STAFF REPORT

Application:	FP20-0009, Final Plat, Cedar Ridge Reserve, Third Plat		
Location:	Northwest of College Boulevard and Woodland Road		
Applicant/Owner:	Tom Bickimer, Bickimer Construction, Inc.		
Engineer:	Tim Tucker, Phelps Engineering, Inc.		
Staff Contact:	Kim Hollingsworth, AICP, Senior Planner

Aerial View of the Subject Property

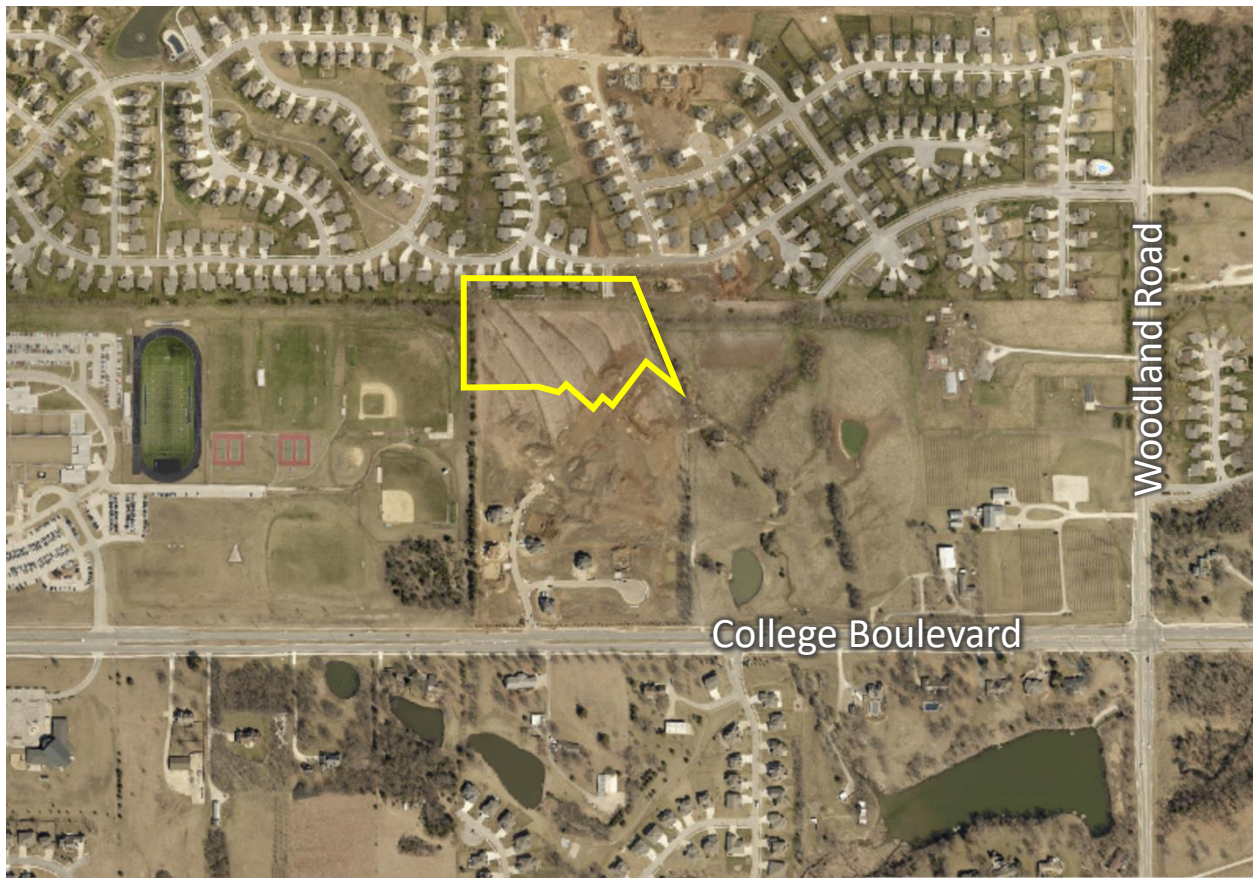
- a. **Lots/Tracts** – The plat includes 14 lots and one common tract and is consistent with the layout of the preliminary plat. The single-family lots range in size from 10,080 to 18,708 square feet with an average lot size of 13,500 square feet and all lots exceed minimum UDO requirements for lot sizes. The common tract is intended to contain drainage areas, and open space that will be owned and maintained by the Homes Association.
- b. **Public Utilities** – The subject property is located within the WaterOne water and Johnson County Wastewater sewer service area. Several easements including Utility Easements (U/E), Sanitary Sewer Easements (S/E), and a Tree Preservation Easement (TP/E) will be dedicated with this final plat. A 100-foot wide powerline easement for Every extends along the eastern plat boundary.

- c. **Streets/Right-of-Way** – Access to the third phase of Cedar Ridge Reserve will be provided primarily from Palisade Street. Additional right-of-way will be dedicated for Race Street which provides a connection to the Prairie Point and Woodland Manor subdivisions to the north. Sidewalks will be provided on one side of all local streets and on both sides of collector roadways within the platted area.

- d. **Stormwater/Detention** – The final plat will be required to meet Title 17 requirements and the HOA agreement regarding the maintenance of the stormwater quality BMP's must be provided to staff prior to recording of the plat.

- e. **Landscaping** – Street trees will be provided along all local and collector streets within the platted area. A tree preservation easement is dedicated along the west boundary of the plat to preserve a line of mature trees that separates the subdivision from the school district property to the west.

Staff recommends approval of FP20-0009 with the following stipulations:

1. Prior to recording, a digital file of the final plat (PDF) must be submitted to the Planning Division.

2. A copy of the HOA agreement that describes maintenance obligations of the post construction stormwater quality BMP's must be provided prior to recording of the final plat.
3. A street tree plan must be approved prior to recording the of the final plat in accordance with the requirements of UDO 18.30.130.
4. Tree preservation fencing must be installed around all Tree Preservation Easements in accordance with UDO 18.30.240.E.
5. All new on-site wiring and cables must be placed underground.
6. Above ground electrical equipment and telephone cabinets must be placed in the rear yard.
